Entergy Nuclear Operations, Inc.
Pilgrim Nuclear Power Station
600 Rocky Hill Road
Plymouth, MA 02360

Proposed Change to Applicability of Pilgrim's Pressure-Temperature Curves as Described in Technical Specification Figures 3.6.1, 3.6.2, and 3.6.3, Revision 1

LETTER NUMBER: 2.02.100

PROPOSED TECHNICAL SPECIFICATIONS CHANGES (MARK-UP)

FIGURE 3.6.1
Pilgrim Reactor Pressure Vessel Pressure-Temperature Limits for Hydrostatic Leak Tests

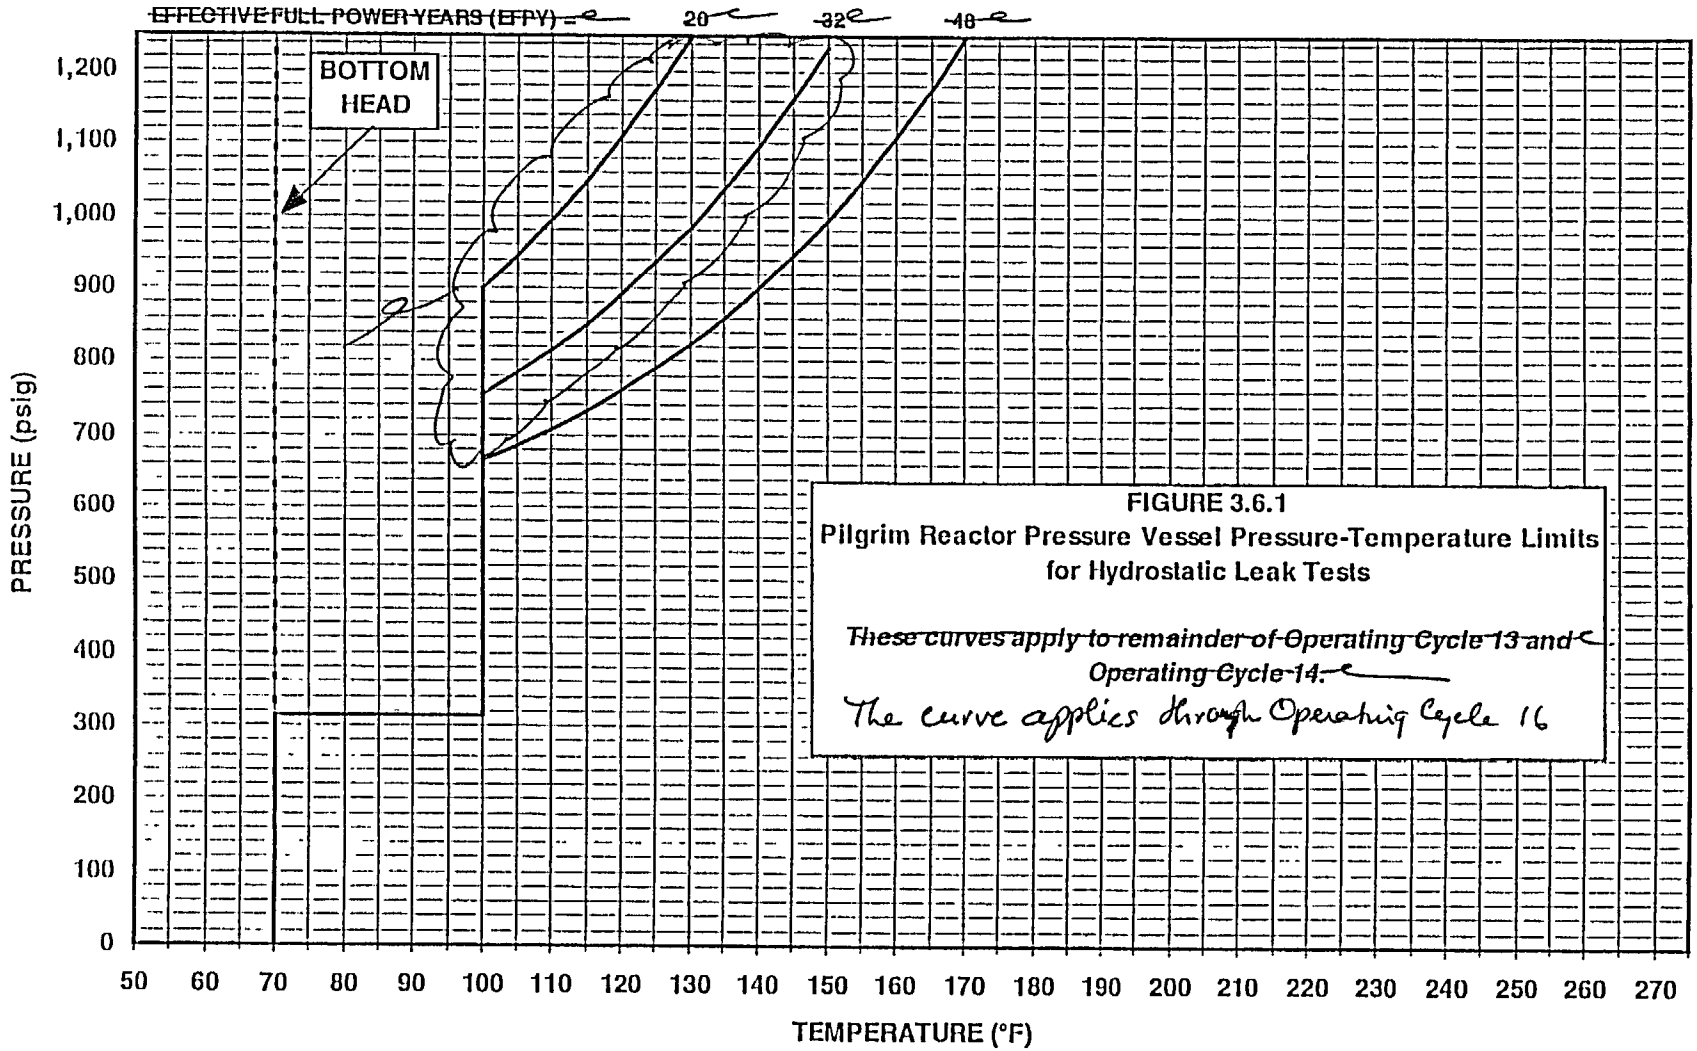
~~These curves apply to remainder of Operating Cycle 13 and Operating Cycle 14.~~

The curve applies through Operating Cycle 16

FIGURE 3.6.2
Pilgrim Reactor Pressure Vessel Pressure-Temperature Limits for Subcritical Heatup and Cooldown

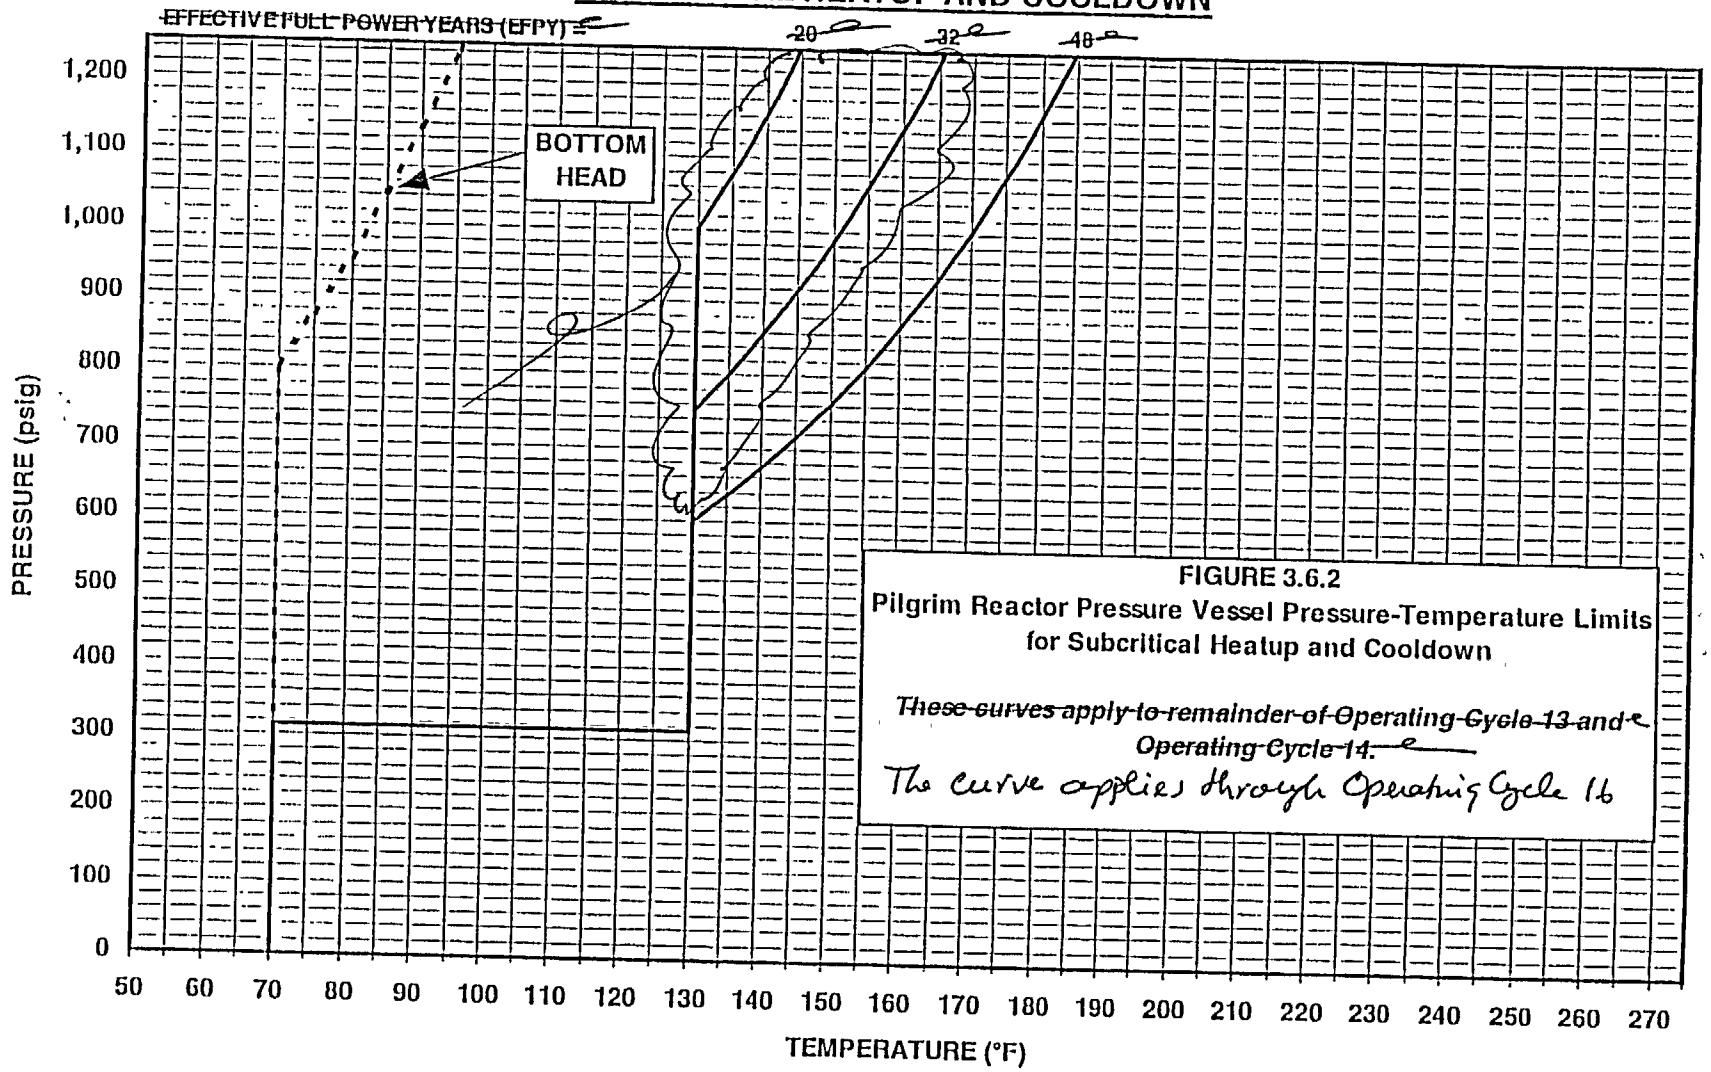
~~These curves apply to remainder of Operating Cycle 13 and Operating Cycle 14.~~

The curve applies through Operating Cycle 16
